CITY OF KENORA

**TENDER #313-001-25
2026 City of Kenora Municipal Paving Program**

ADDENDUM No. 1

Title
 ELECTRICAL
 LAKEVIEW DRIVE
 TRAFFIC SIGNALS PLAN

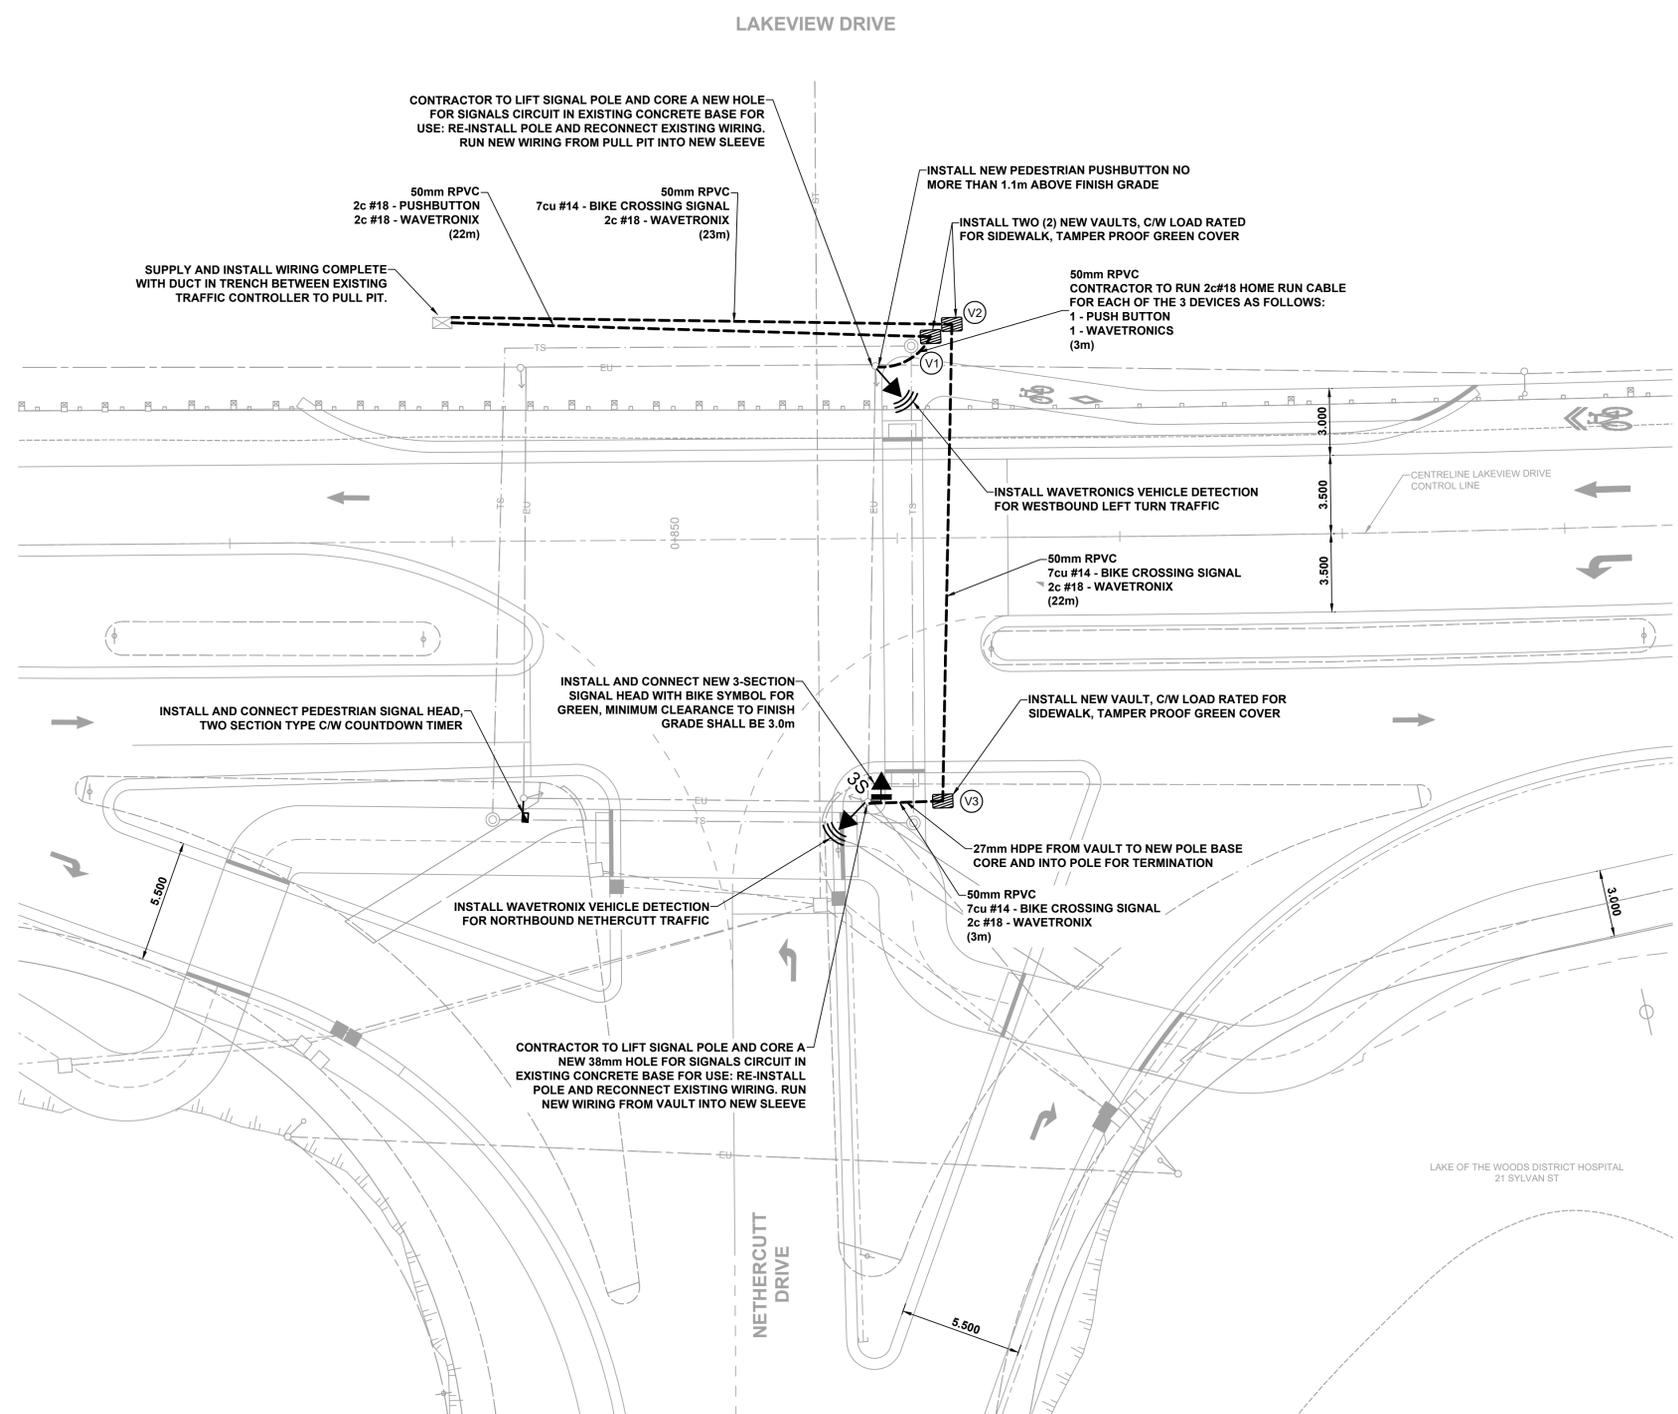
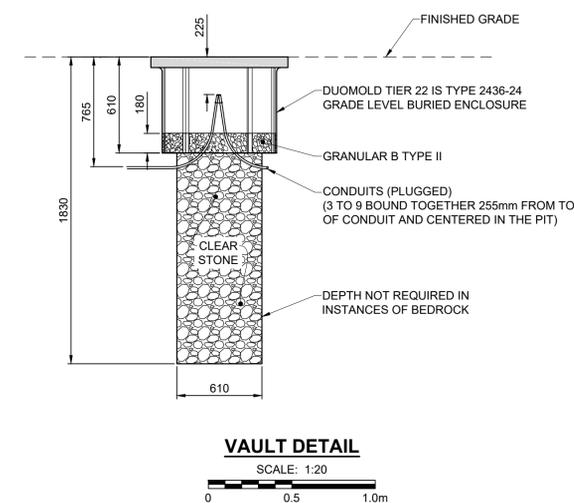
Drawing C-031 Electrical Lakeview Drive Traffic Signals Plan, Revision 0 Issued For Tender

Drawing C-031 Electrical Lakeview Drive Traffic Signals Plan, Revision 1 Addendum

Q: The Vault Detail on Drawing C-031 shows a Type 2436-24 enclosure. Would a Channel BULK 4 Grade Level Box be an acceptable alternative for the specified vault product?

A: Channel BULK 4 Grade Level Box is an acceptable alternative for the vault product shown on the Vault Detail on Drawing C-031.
